GW - 001

**GENERAL
CORRESPONDENCE**

Re: Plateau, Inc. Discharge Plan

Figure 3

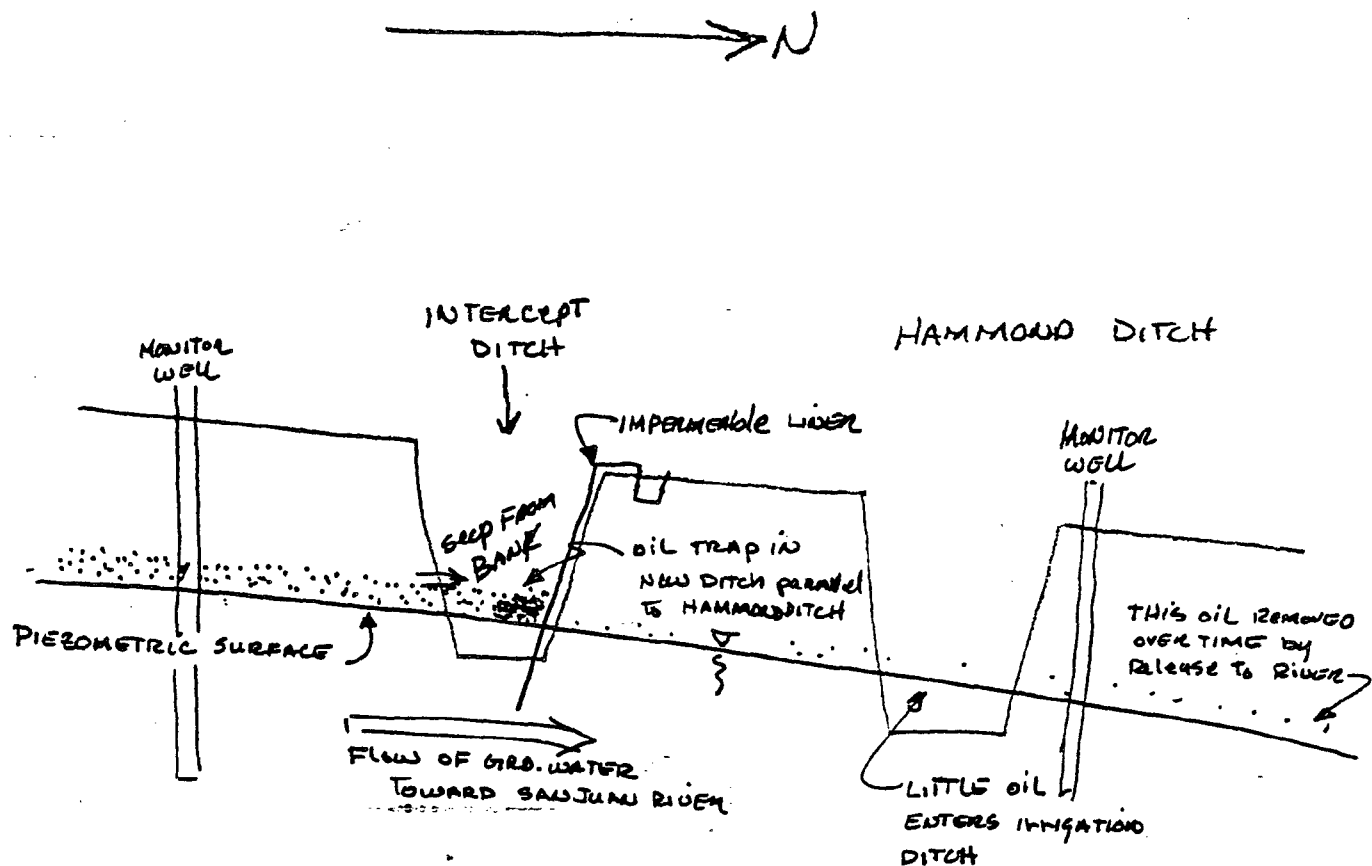
8. The area of heavily polluted soils containing oil (inspised oil) will continually recharge the Hammond Ditch. This area should be treated to intercept the oils for disposal. The oil is lighter than water hence will be present on the piezometric surface. This does aid in capture of the oil if it is moving toward the ditch. Figure 1 indicates that during the summer irrigation season the oil on the surface should flow to the south because the piezometric surface should dip in that direction due to heavy recharge to the aquifer by the ditch. Then as the irrigation season ends the ditch no longer recharges the aquifer and the piezometric surface reverses allowing the oil to flow northward into the ditch and likely beyond to seeps in the cliff.

The oil can be captured using the method shown in Figure 3. The existing monitor wells may be useful in design of such a clean up operation. The problem with removal wells is the requirement for constant pumping and a place to dispose of the wastestream. Using the ditch method it is possible to hold the oil until the plant manager is ready to remove the oil scum.

The oil on top of the water would be trapped behind the impermeable liner for later collection and disposal. Depth of oil and water must be determined before design and construction of intercept ditch.

Figure 4a

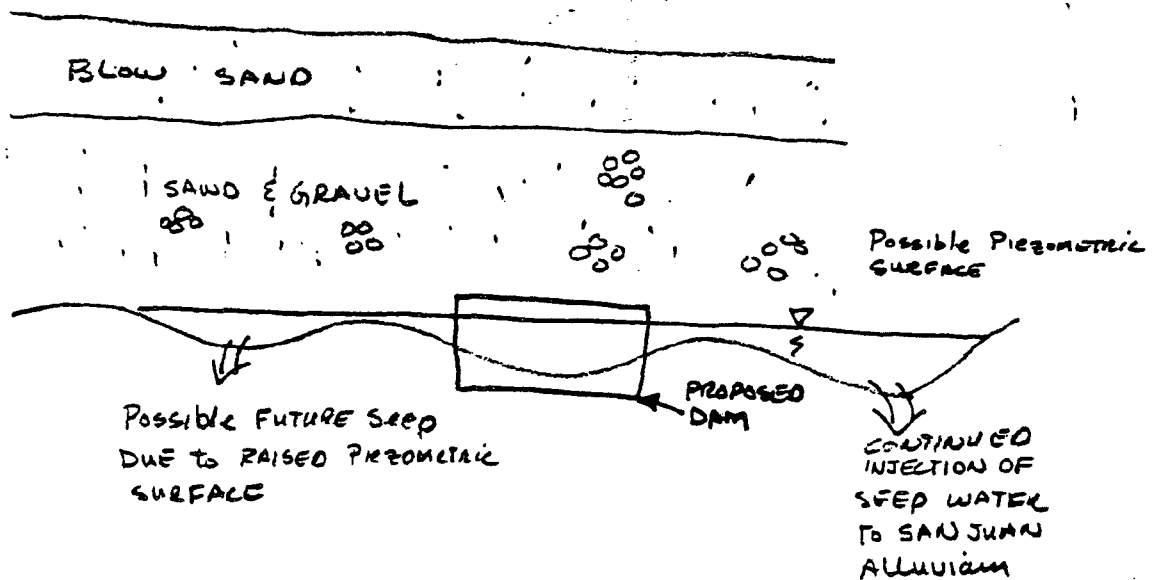
15. The proposal to recycle the wastewater from the seeps does not eliminate the chance for further pollution of the San Juan River alluvium. According to the Plateau report the Nacimientos formation is undulating as seen in the exposed section of the Cliff. Therefore, once a dam is placed at a seep the water level will rise and may seek an outlet requiring less hydraulic head. Figure 4 shows the potential for continued injection into the river aquifer which essentially will continue the existing situation. According to the Plateau plan these new seeps would also have a dam built. It does not seem to be a reasonable scheme for protection of the groundwater. In addition, according to the literature the Nacimientos formation does have layers of sand that can transmit water at high flow rates. The information provided does not exclude the possibility that wastewater is recharging such layers in the formation.

Existing Condition of Seep at
the Interface of the Nacimientto
Formation and Sand and Gravel

Possible Condition of Seep at
the Interface of the Nacimientto
Formation and Sand and Gravel
Due to Raising the Piezometric
Surface

Figure 3. Map of Plateau refinery and vicinity showing elevation of the contact between the Nacimientos Formation and the cobble bed.

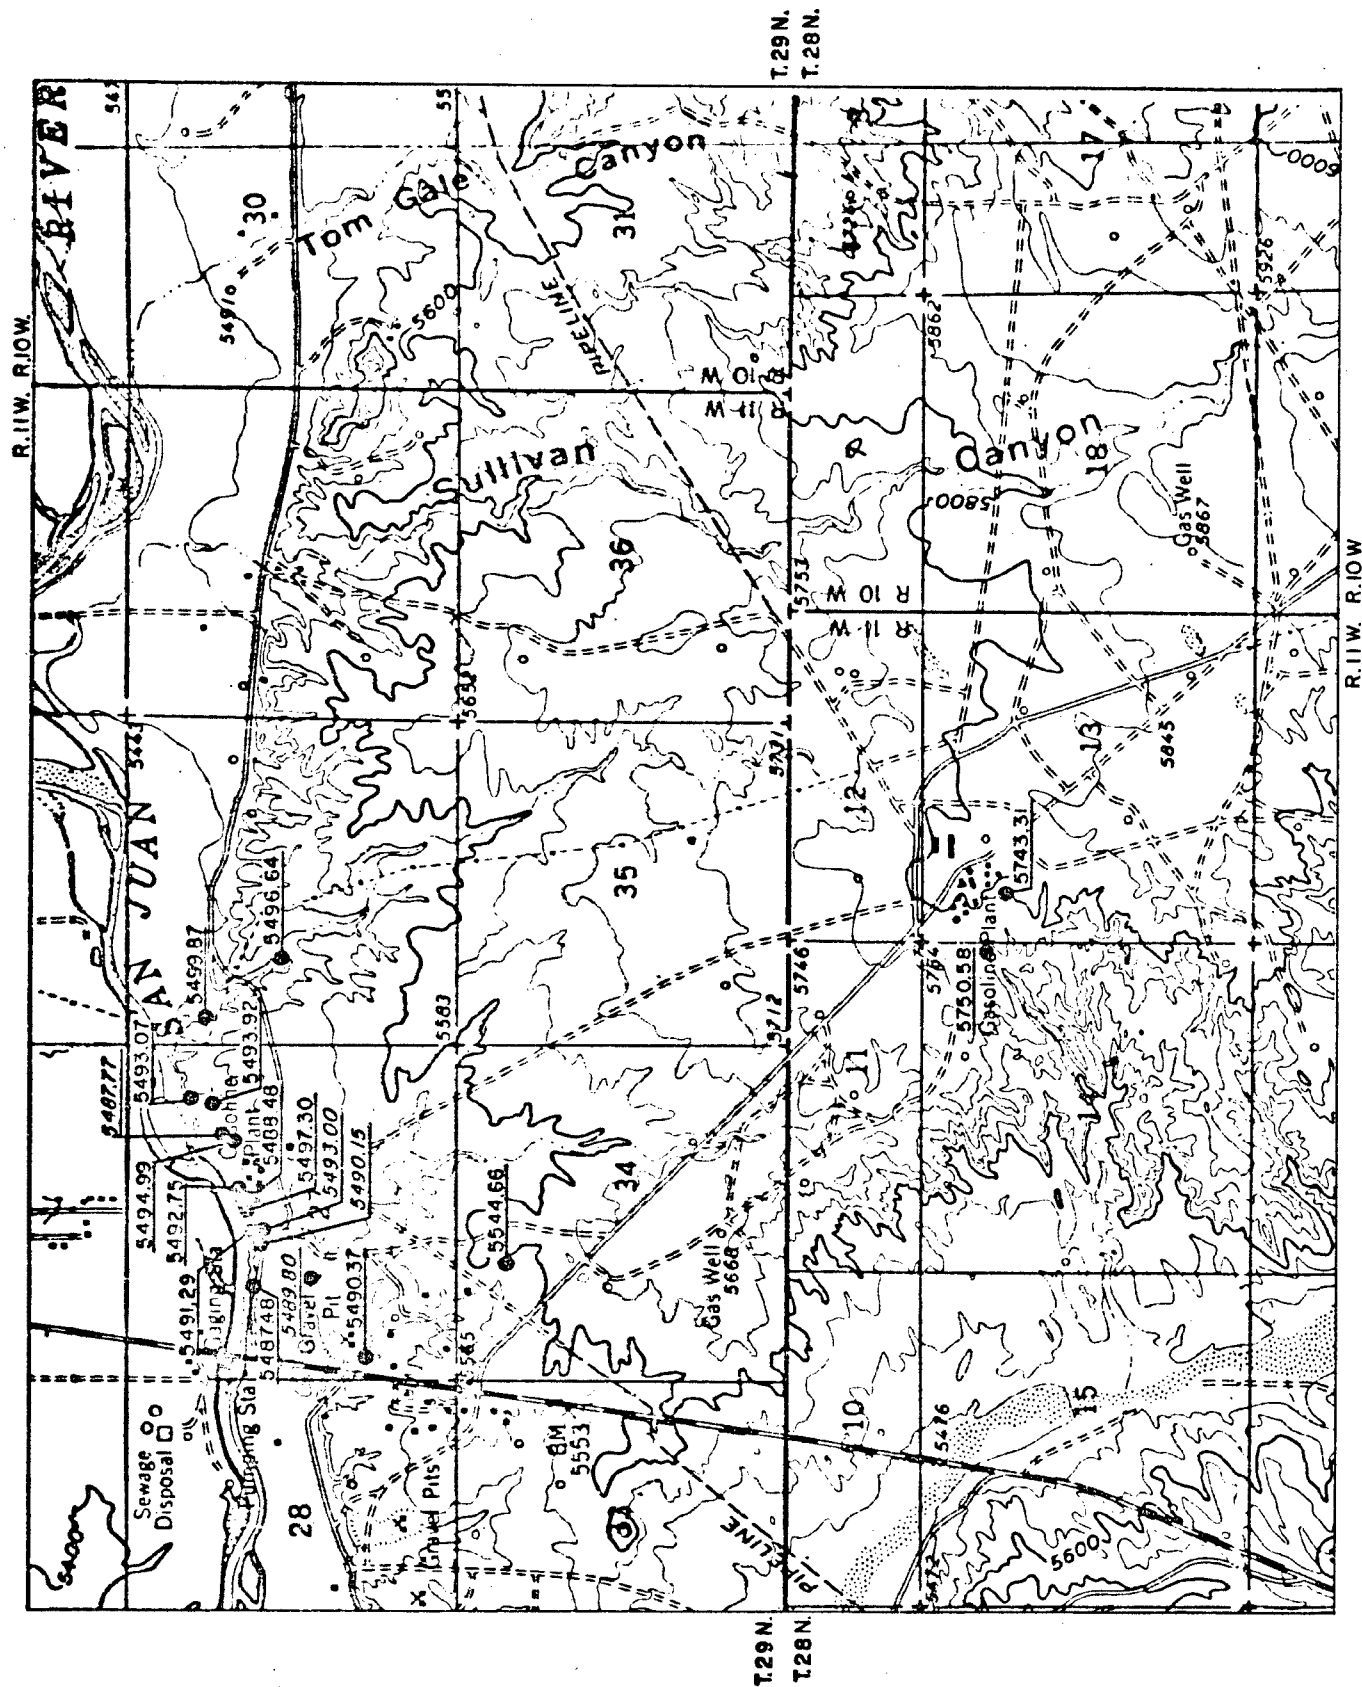
It is evident from figure 3 that the slope of the subcrop beneath the cobble bed is to the north or northwest at about 1.2 degrees. It is also evident that the subcrop topography is slightly undulose and this is easily visible in the outcrop. The spatial occurrence of the cobble bed indicates that it is dry. Any natural recharge to the cobble bed would drain to the north and either discharge into one of the southward trending valleys or onto the northward facing cliff immediately north of the refinery. All seeps indicated on Plate 1 were present before the evaporation ponds were filled. All seeps have been closely observed for a period of almost four years. The Hammond Ditch has been walked during January from 1978 until the present and in the vicinity of the filled evaporation ponds no detectable seepage has been observed. — *wrong* *Personal OCD observation indicates leakage*

It is concluded, therefore, that there is no naturally occurring ground water within the cobble bed capping the *wrong*

*show how well we recharge
from ditch would
not be a problem
clear*
